E9902G-01

Modification Recommended Service Note

Keysight i3070 Series 6 In-Circuit Test System

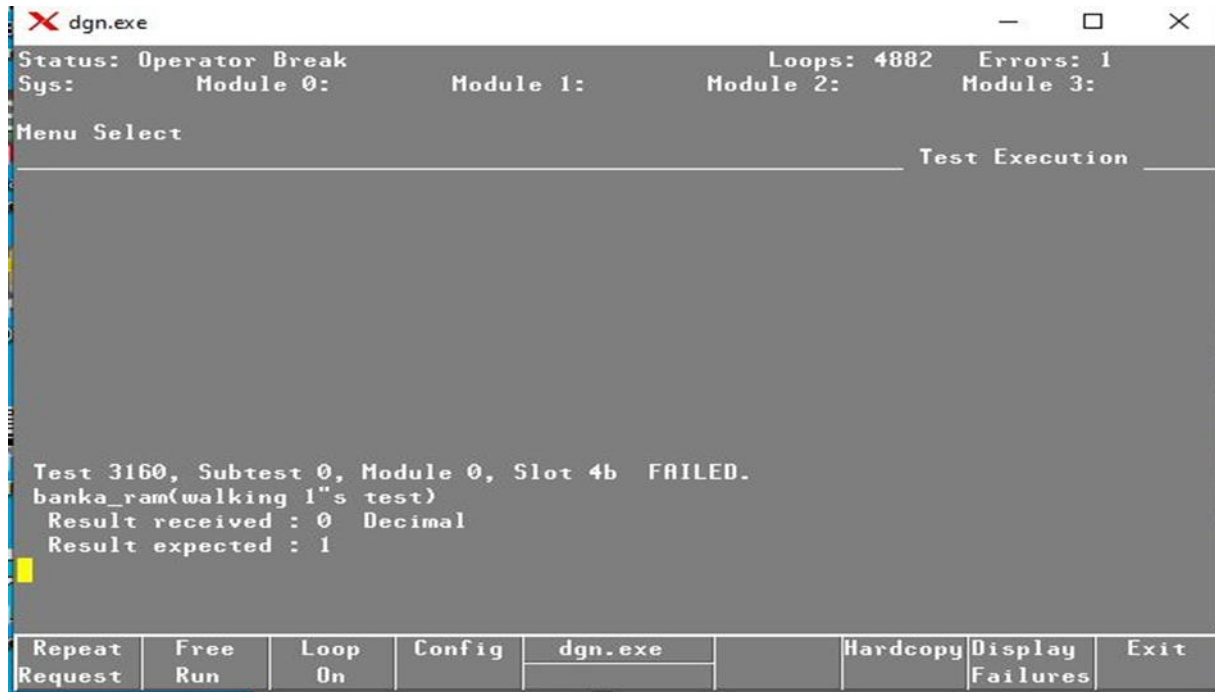
All i3070 Series 6 systems are currently shipped with control XTPB cards. Intermittent T3610 errors are reported during Diagnostics (DGN) on certain batches of pin cards in MUX system only. The following is a screenshot of some of the failures:

A new firmware (v22040514_2) for XTPB card has been developed to address this issue. The new firmware can be downloaded from Keysight.com and the firmware update can be done via DGN.

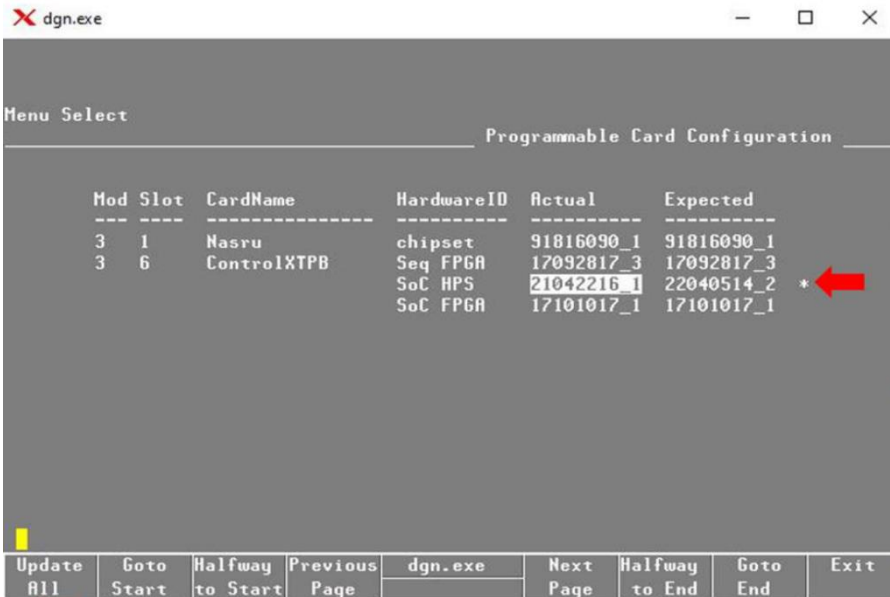
3. Launch DGN.
4. Select Configuration > Programmable Card Config.
5. Any available firmware updates will be highlighted as shown below:

6. Select “Update All” to begin the update.
7. Whenever the User Account Control dialog box appears, select “Yes” to allow the system to proceed.
8. When installation is completed, reboot the testhead.
